UPDATE FILE FOR GYSMI 190

VERSION	MODIFICATIONS	DATE	AUTHOR
1.0	CREATION	27/10/2006	
2.0	PARAGRAPH 5) ANTISTICKING ADDED	25/05/2007	BRUNO BABLEE

Modification of the fans 51021

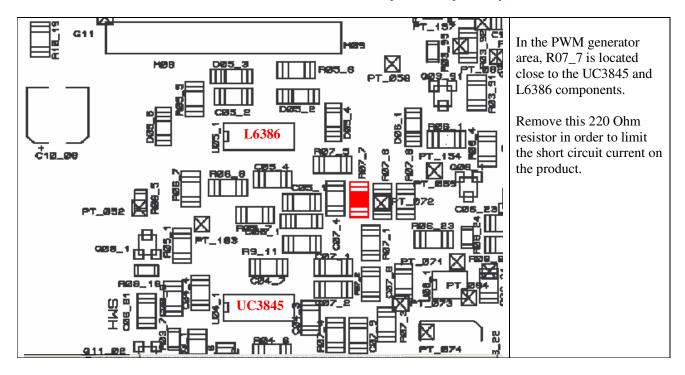
There is a risk of short circuit between the transistor metallic part and the components below.

Raise delicately the transistor with a screwdriver or other tool to separate the component from the fan circuit. Do the same for the other transistor located on the opposite side.

To eliminate this risk, insert some glue between the transistor and the PCB.

Insert some glue between the metallic part of the transistor and the fan PCB.
